Subject ▶ Change on Clutch Cam

For Models ▶ HR2410 & HR2420 (Rotary Hammer 24mm)

▶ Current	▶ New
<p>Material:Forged Iron</p> 	<p>Material:Sintered Iron</p>

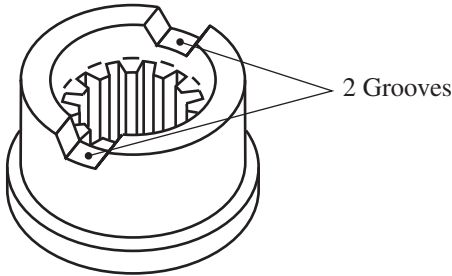
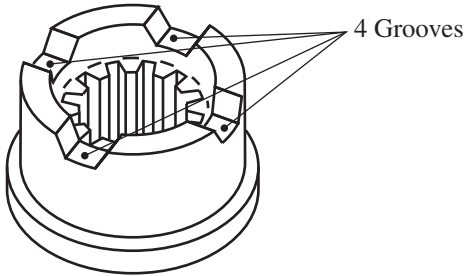
Description ▶ As illustrated below, the shape and the material of Clutch Cam has been changed for improvement of endurance.

Item No.	Current part		Q'ty	I/C	New part		Q'ty	Note
061	Clutch Cam 322743-7		1	<=	Clutch Cam 322939-0		1

HR2410 : From Serial No. 129379E (Jan., 1997)

HR2420 : From Serial No. 4306E (Jan., 1997)
